Partial load for annex 3 France

7th session of the GRB Informal Working Group
Additional Sound Emission Provisions (ASEP), March 20-22, 2018
Changchun, Jilin province, China

Example vehicle 2 (diesel)

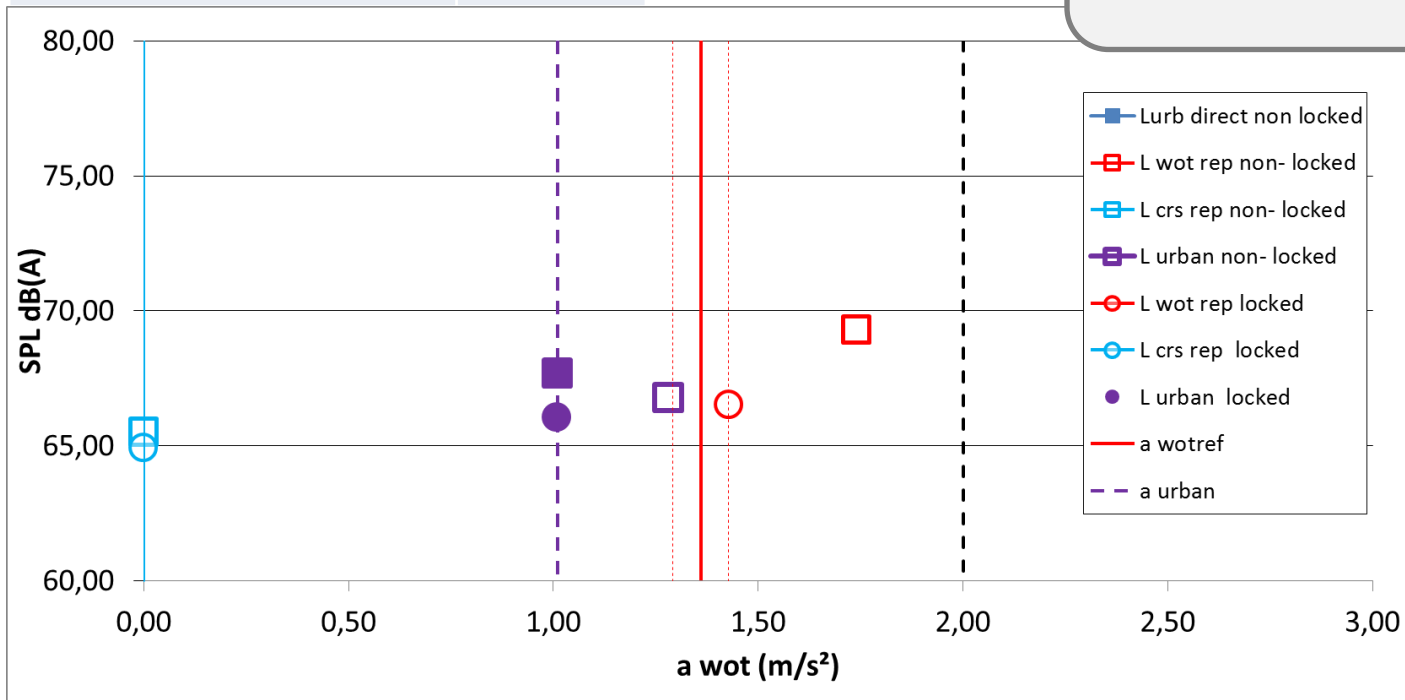
In this case, similar results between L urb direct and L urban

Example vehicle 2 (diesel)

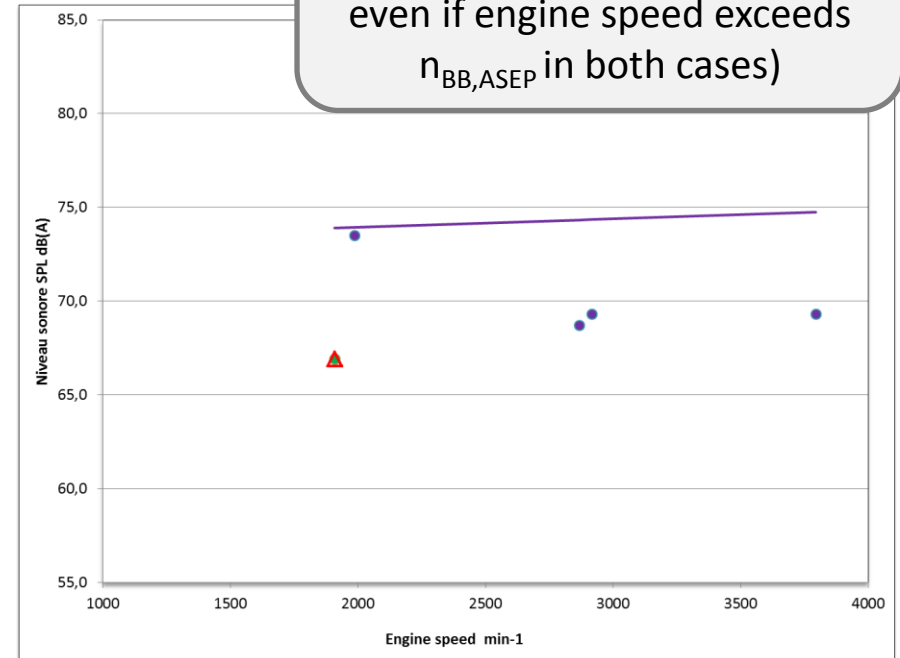
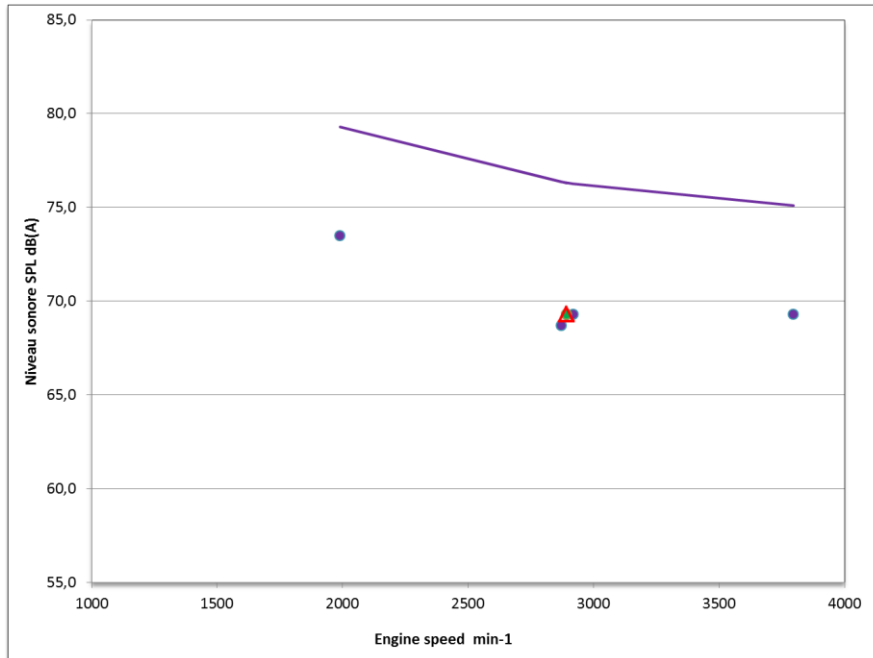
In this case, different slope and
“distance” to limit
even if engine speed exceeds
 $n_{BB,ASEP}$ in both cases)

Example vehicle 3 (Gasoline)

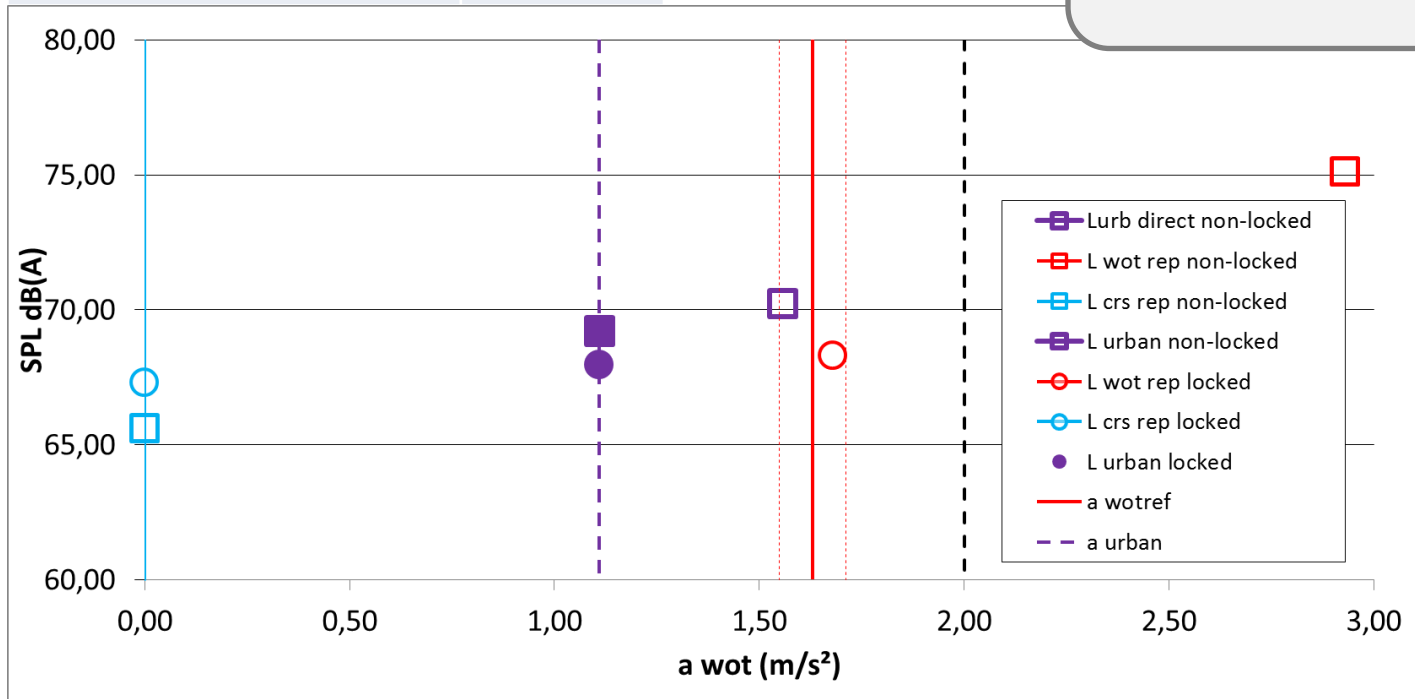
In this case, similar results between L urb direct and L urban

Example vehicle 3 (Gasoline)

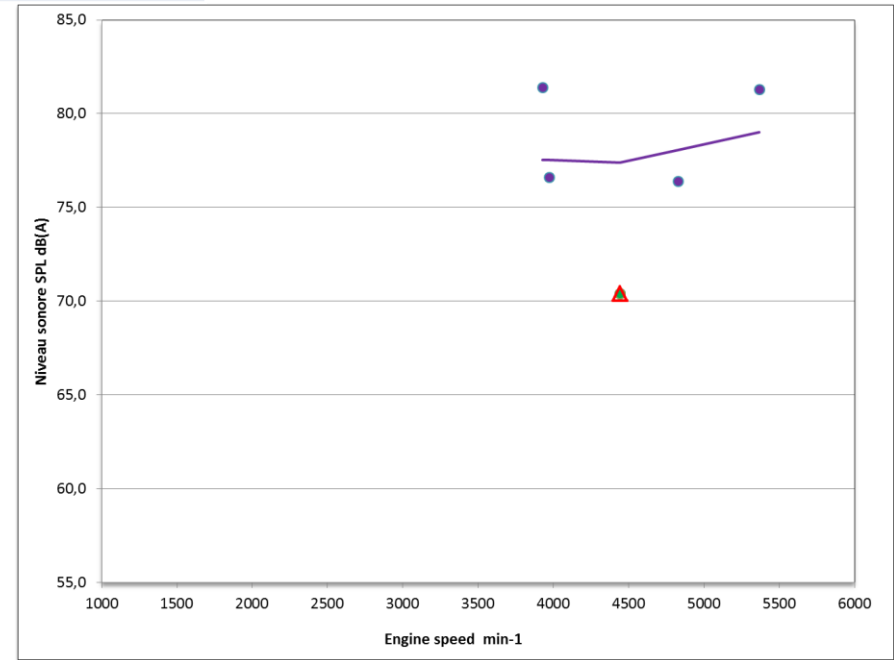
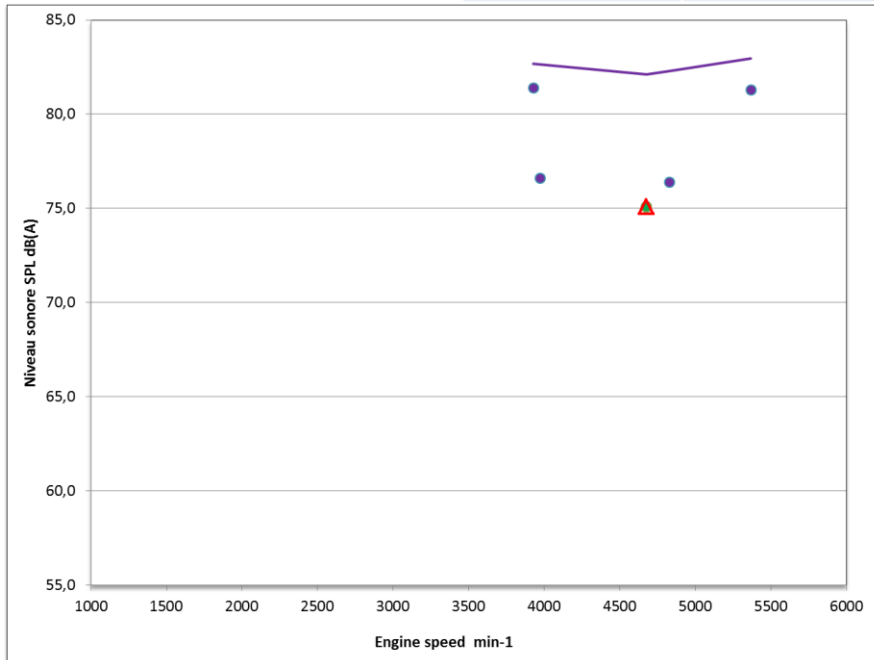
In this case, different compliance (even if engine speed exceeds $n_{BB,ASEP}$ in both cases)
